# Comal County Environmental Health OSSF Inspection Sheet

## Permit of Authorization to Construct an On-Site Sewage Facility Permit Valid For One Year From Date Issued

Permit Number: 117363  
Issued This Date: 05/01/2024  
This permit is hereby given to: Alejandra Lopez Toledo Gonzalez

30251 LEROY SCHEEL RD  
BULVERDE, TX 78163

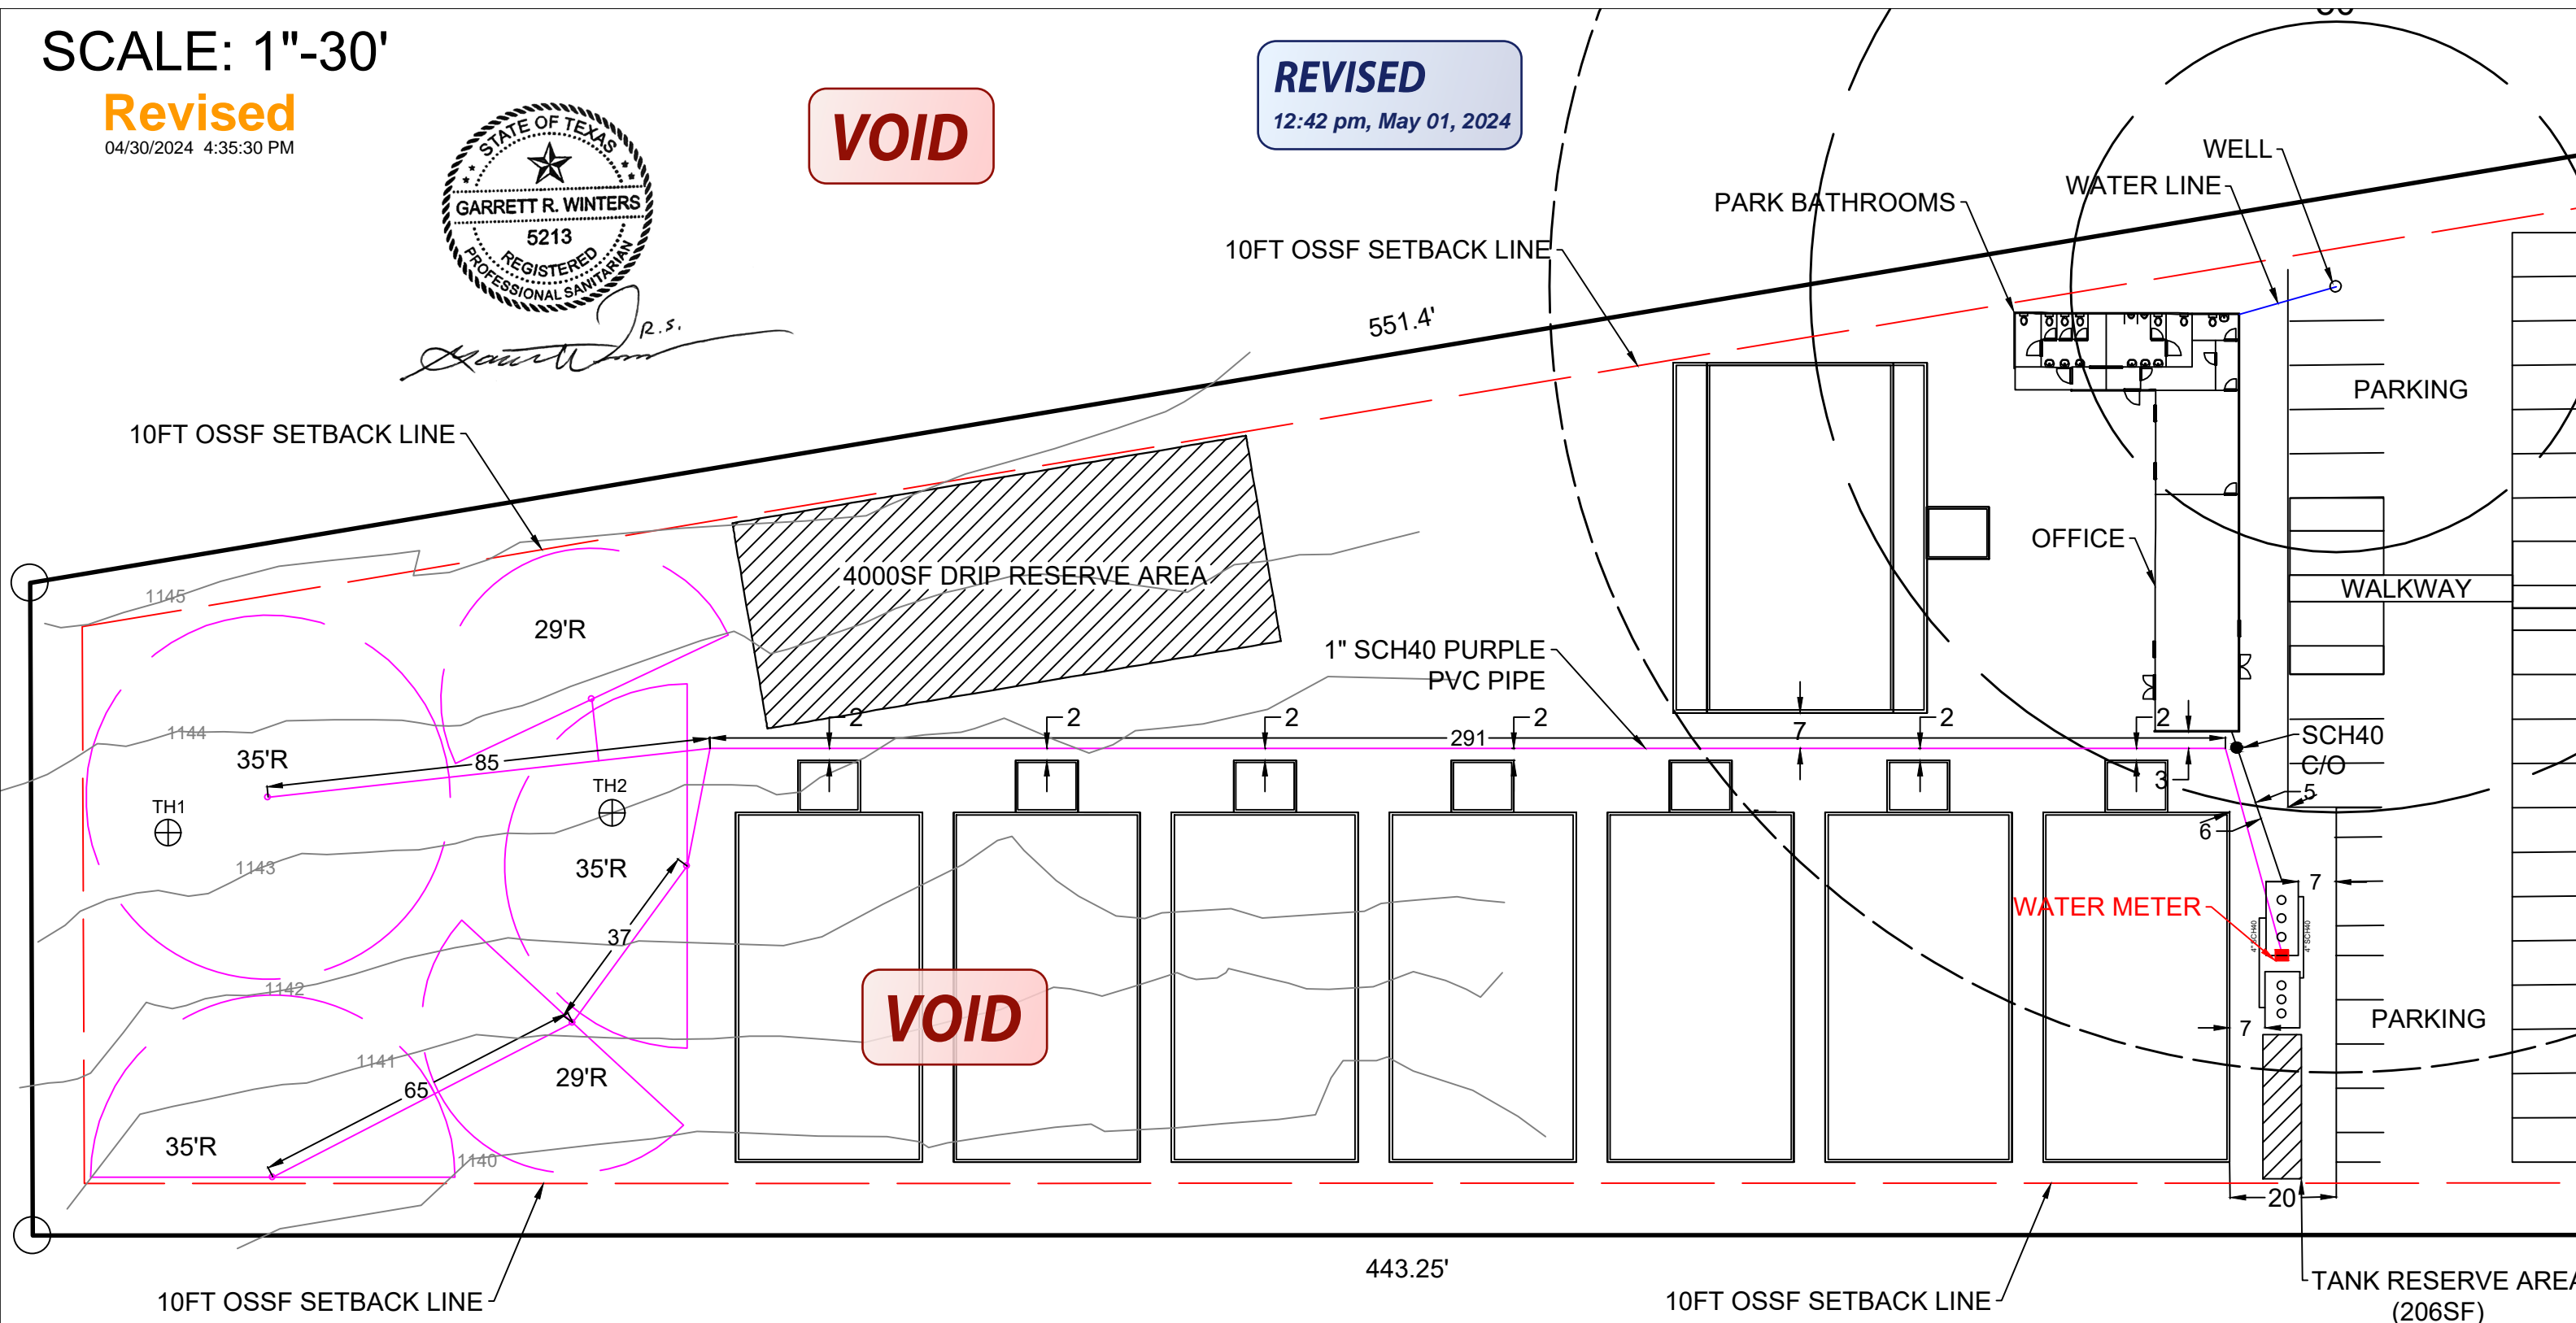
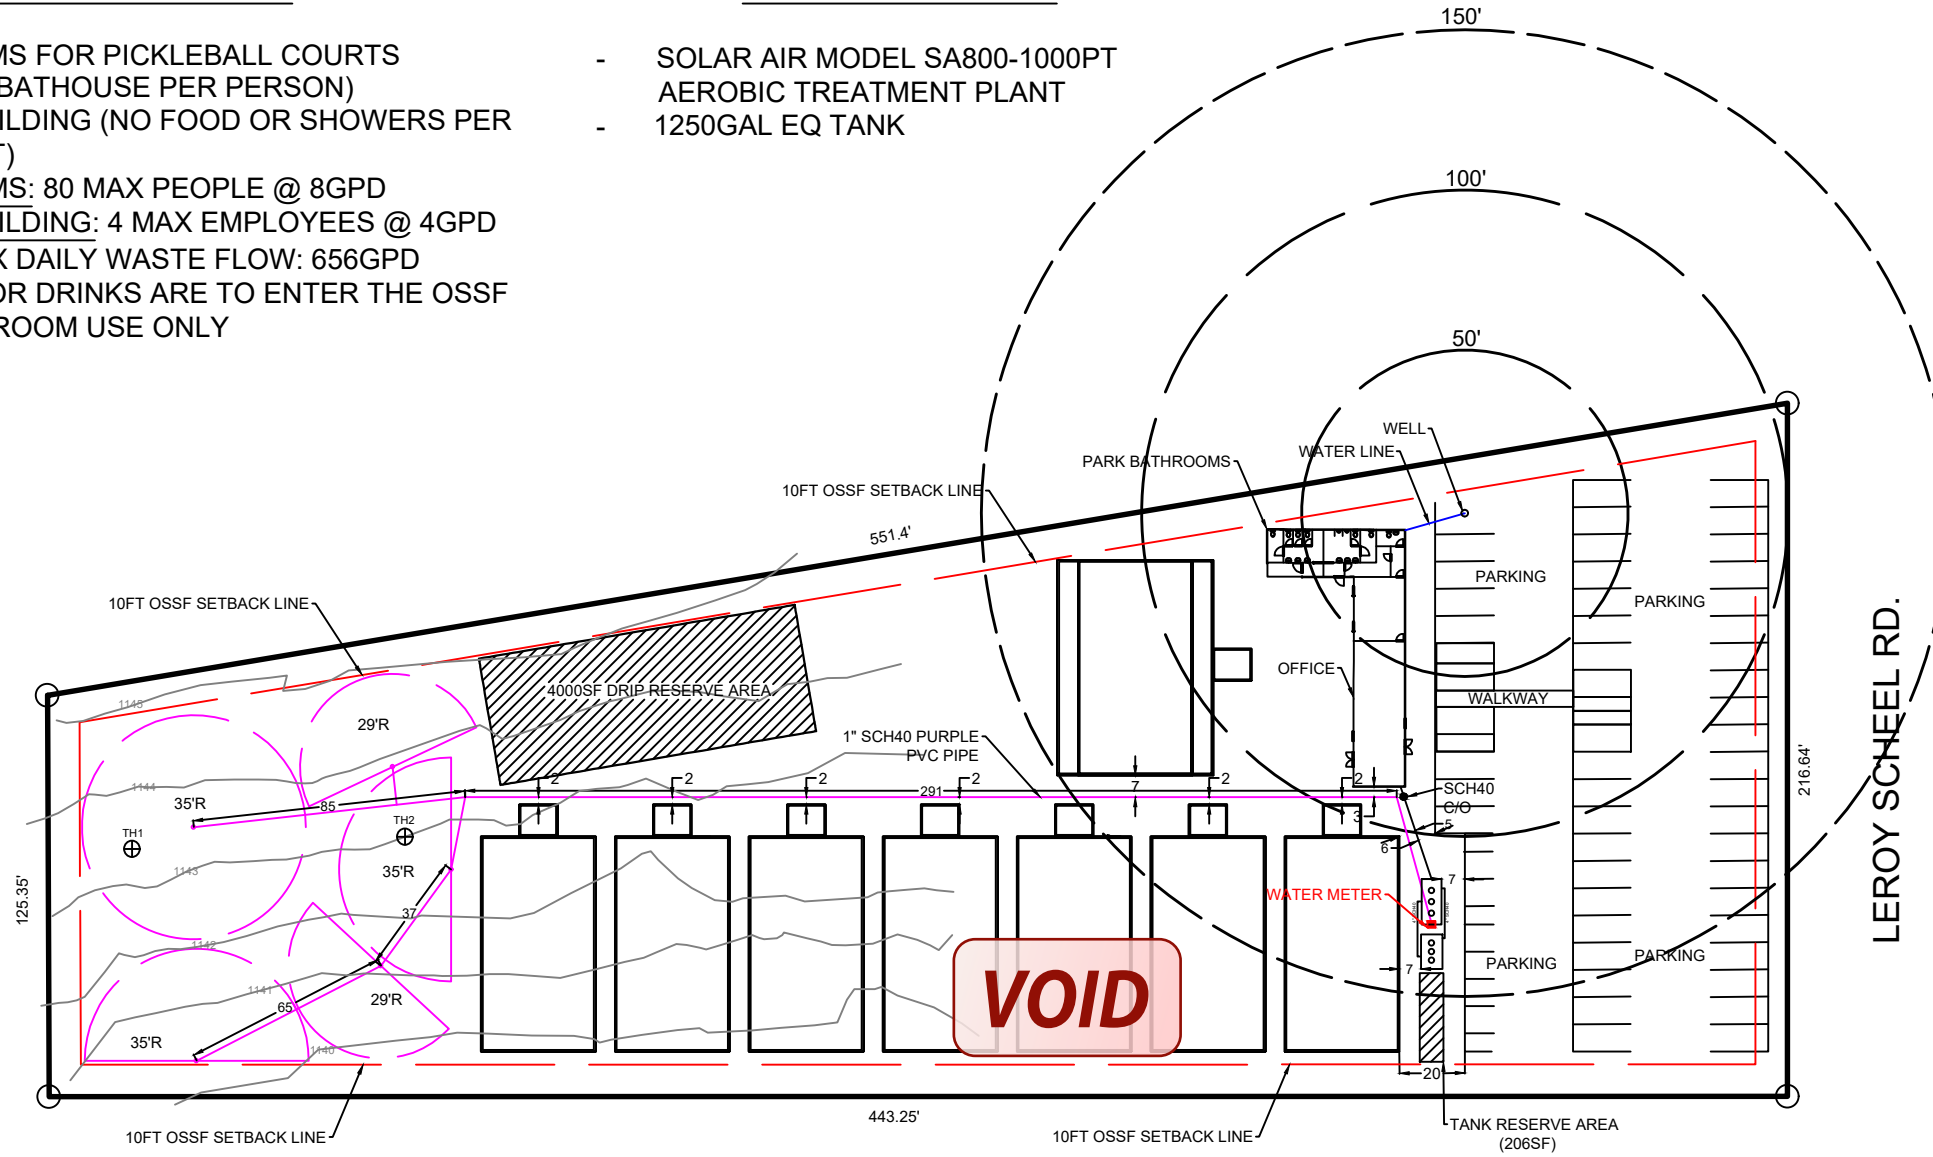
- Updated to show neighboring WELL
- WELL location Change on Property

DATE	DESCRIPTION	REV#
	WELL SETBACK 150'	1
	SEPERATION DIST.	
	WATER METER ADDED	
5/8	NEIGHBORING WELL ADDED	2
	WELL LOCATION CHANGE

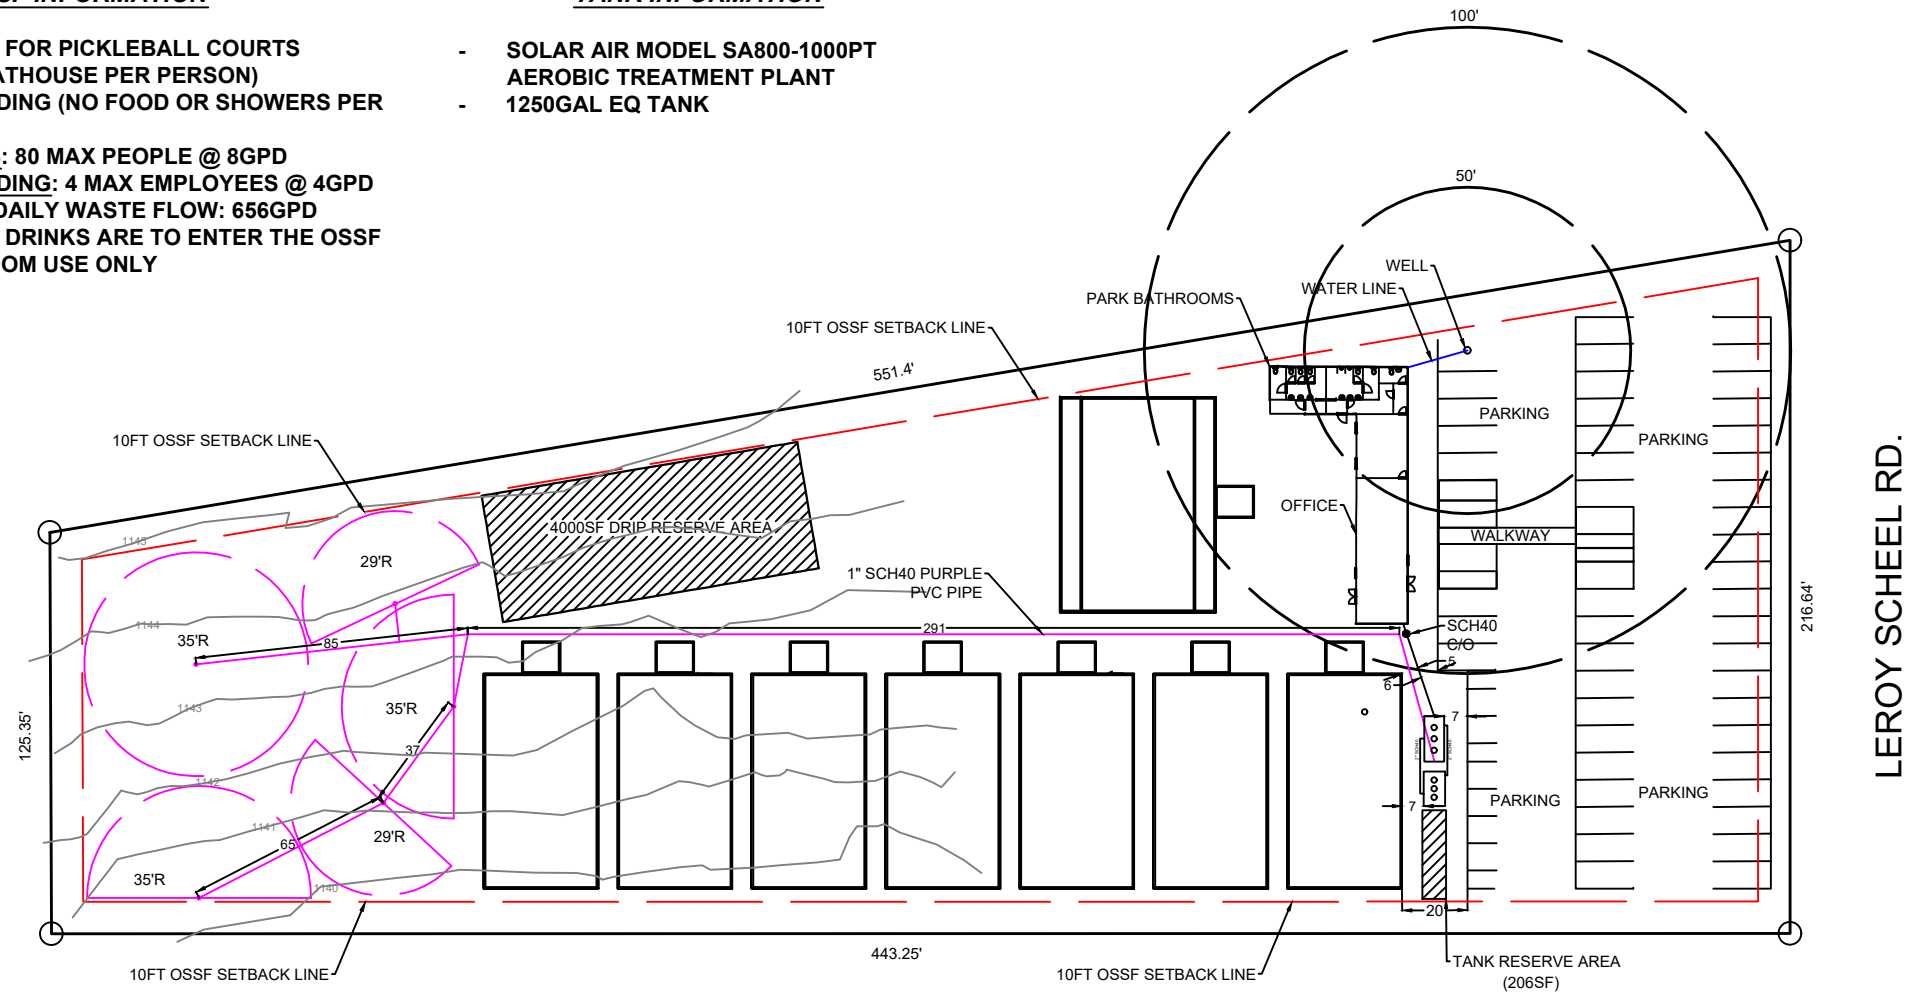
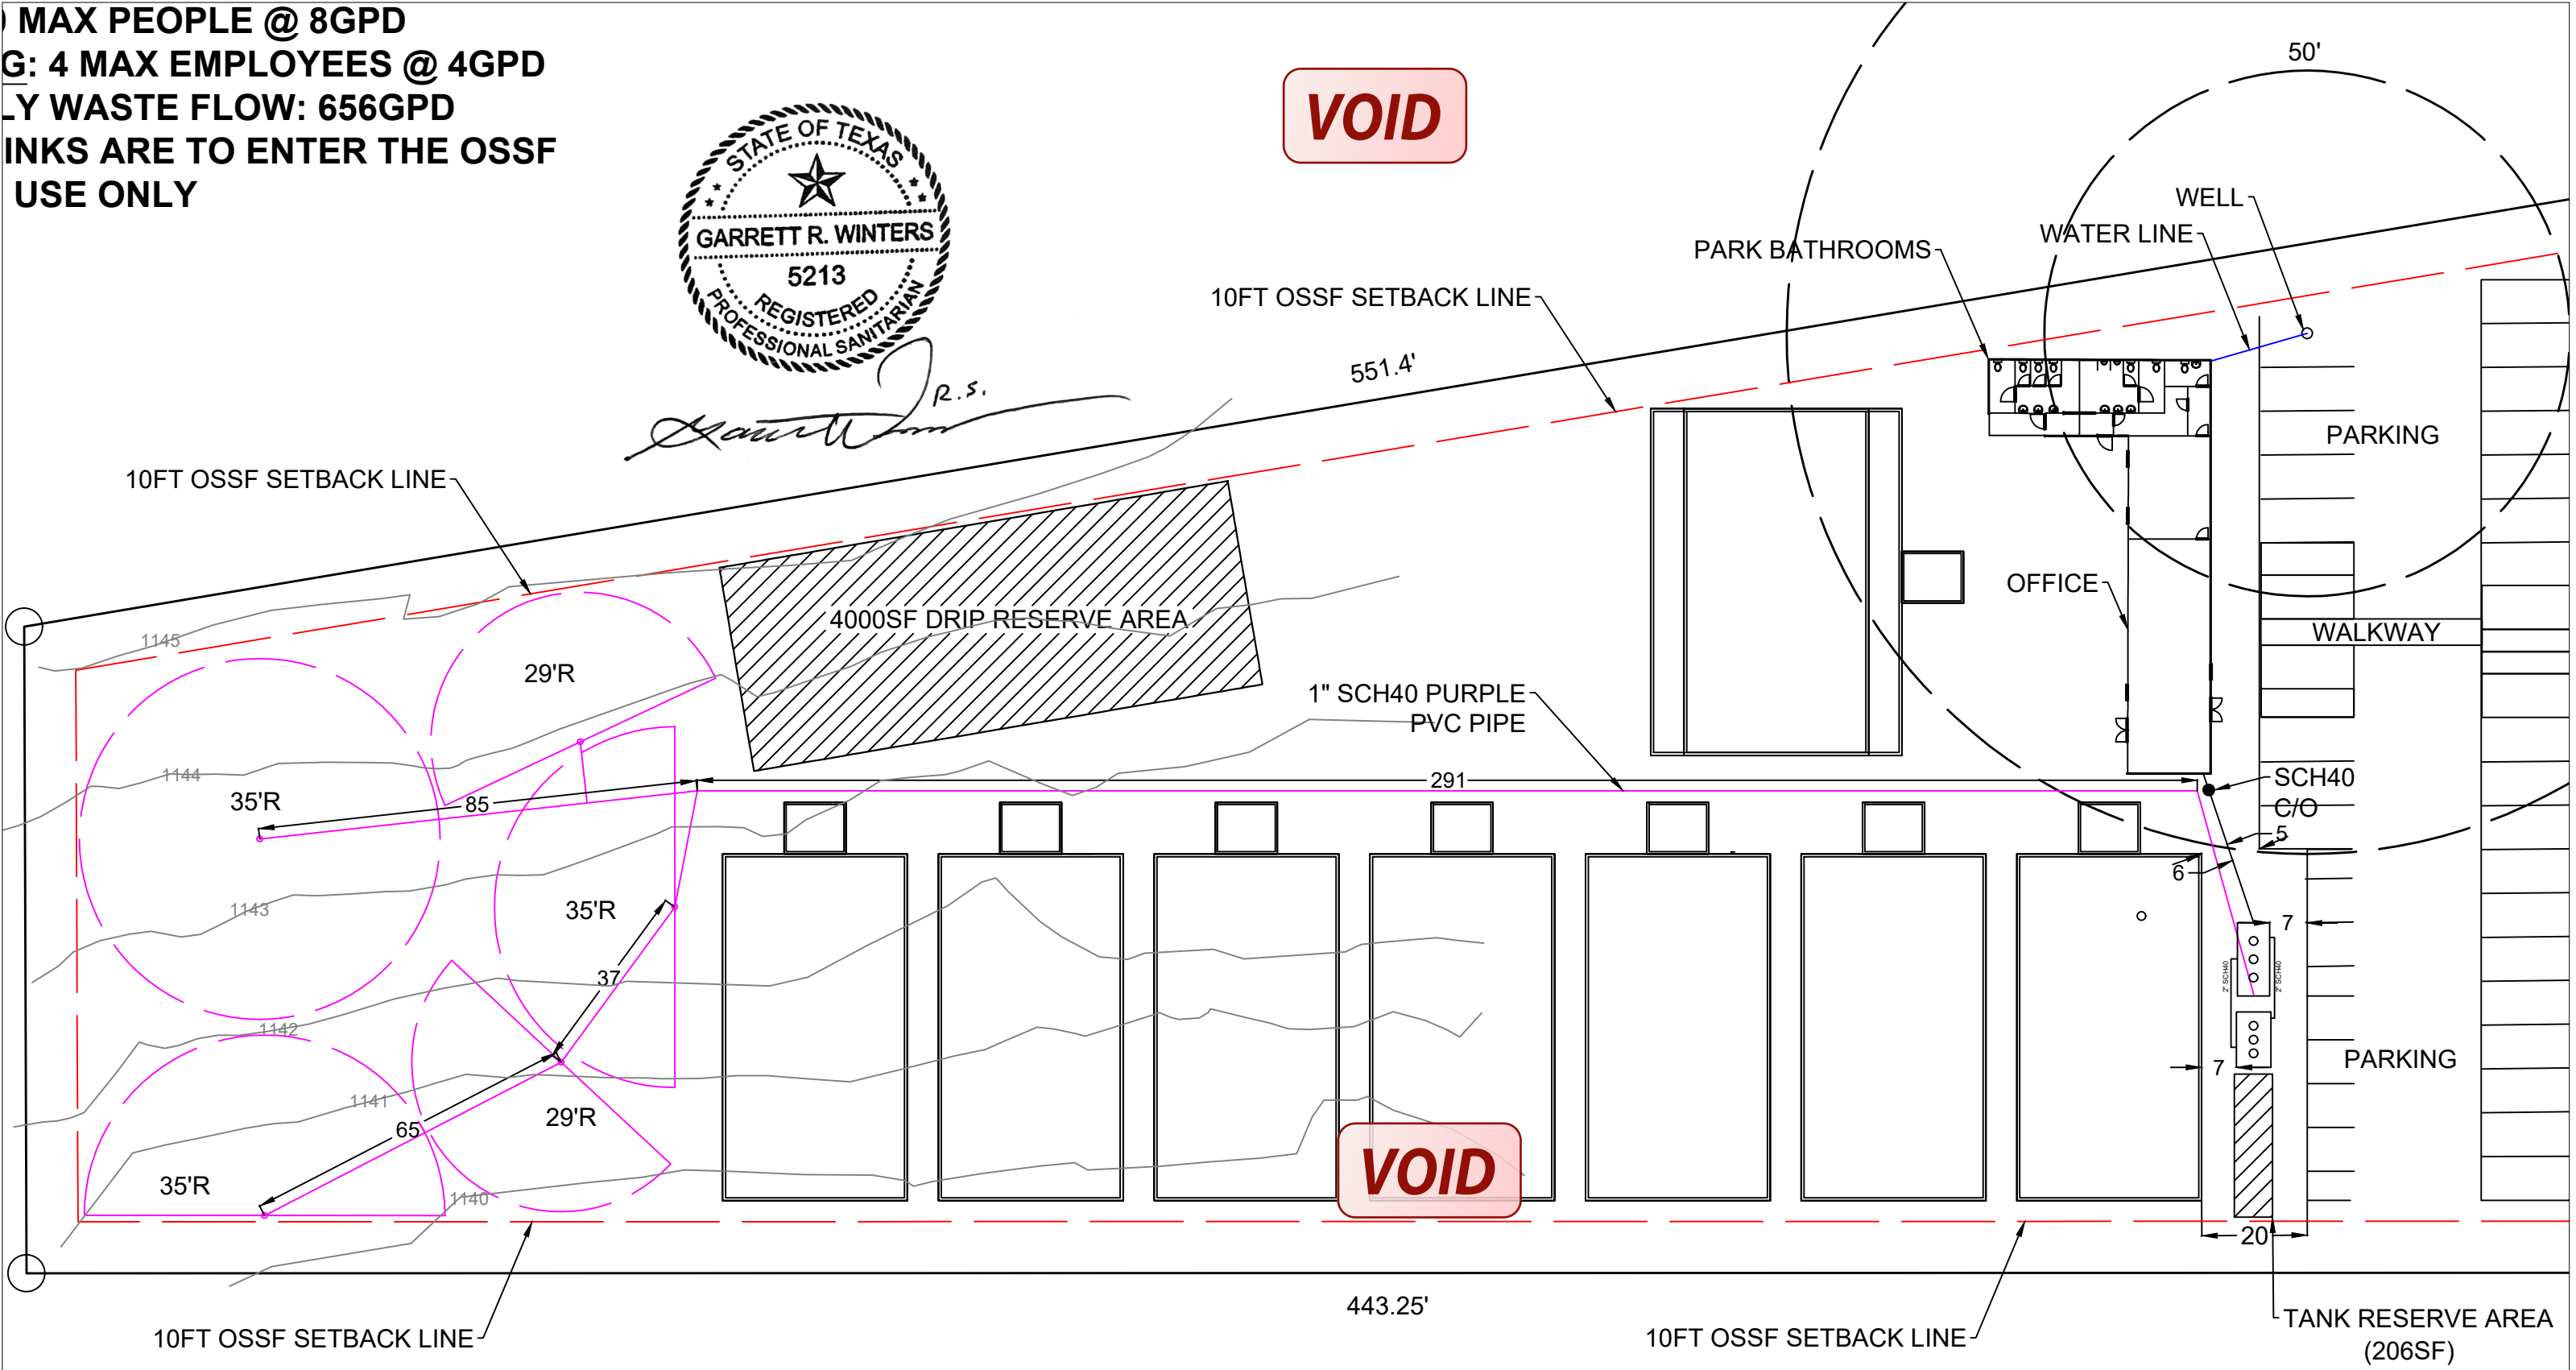
-  **It does not appear that this property meets our Comal County Rules for OSSF's minimum lot size requirements. See attached OSSF Lot Size Determination of Compliance for reference.**
-  **Show 150 ft. setback around the water well.**
-  **Indicate the separations distance of the sewer line to all surface improvements.**
- 4. As a condition of the License to Operate for this permit a flow meter must be placed on the outflow line of the pump tank. Meter readings from this meter must be recorded daily. A log of the daily meter readings must be submitted to our office once a month for 12 months beginning 30 days from the date the License to Operate is issued. If at any time the daily water use exceeds the permitted flow rate, the permit will be void and a new permit must be obtained.**
- 5. Revise as needed and resubmit.**

DATE	DESCRIPTION	REV#
	WELL SETBACK 150'	1
	SEPERATION DIST.	
	WATER METER ADDED
